SERVICE BULLETIN

PRODUCT: Computer Monitor
BULLETIN: MON 97-002
MODEL: CMH7379L

SUBJECT: To prevent whistling sound from occurring.

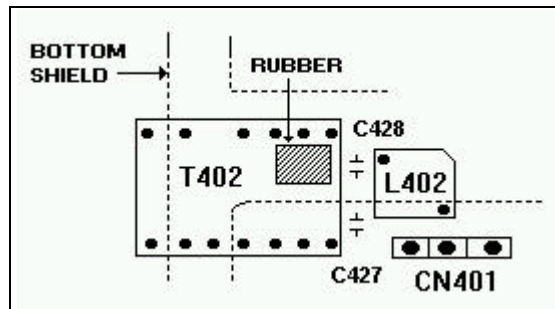
BACKGROUND: A whistling sound is created from harmonic noise generated between T402, L402, and the main PCB near the Flyback Transformer.

SOLUTION: Add a piece of rubber to insulate the main PCB solder side from the bottom metal shield. See Illustration below showing the section of the PCB where the rubber will be located.

Part No.	Description
BH61-30303A	RUBBER

Figure 1

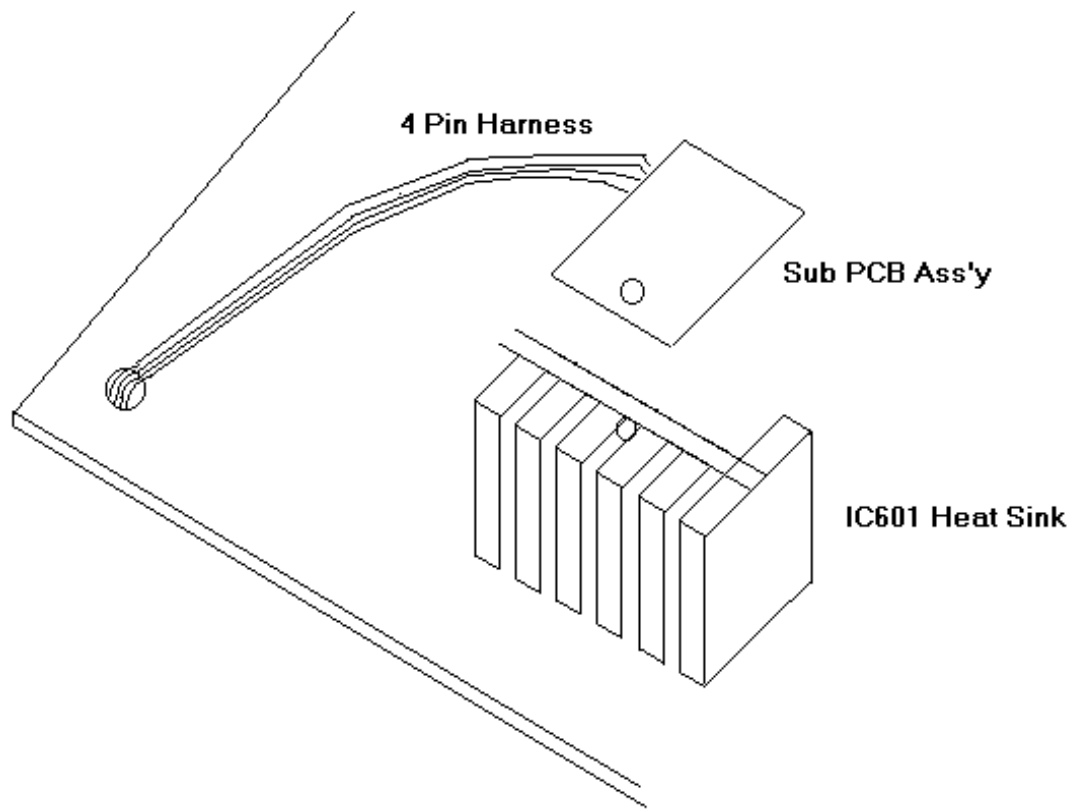
SUBJECT: Q407 Failure Causing No Raster or Small Horizontal Size

BACKGROUND: Q407 fails due to a transient pulse and current when mode switching from DOS to Windows. This occurs with a Matrox video card installed in the computer.

SOLUTION: Add a sub-PCB assembly as in figures 1 and 2 and a snubbing circuit for the horizontal output as in figure 3.

ORIGINAL			NEW	
Location No.	Part No.	Description	Part No.	Description
NA	NA	NA	BH92-50106J	SUB-PCB ASSEMBLY
NA	NA	NA	BH39-40355S	4 PIN CBF-HARNESS
NA	NA	NA	6003-000129	TAPTITE SCREW
NA	NA	NA	0401-000005	1N4148 DIODE
NA	NA	NA	0402-000012	UF4007 DIODE
NA	NA	NA	2003-000009	220 OMHS, 1 WATT
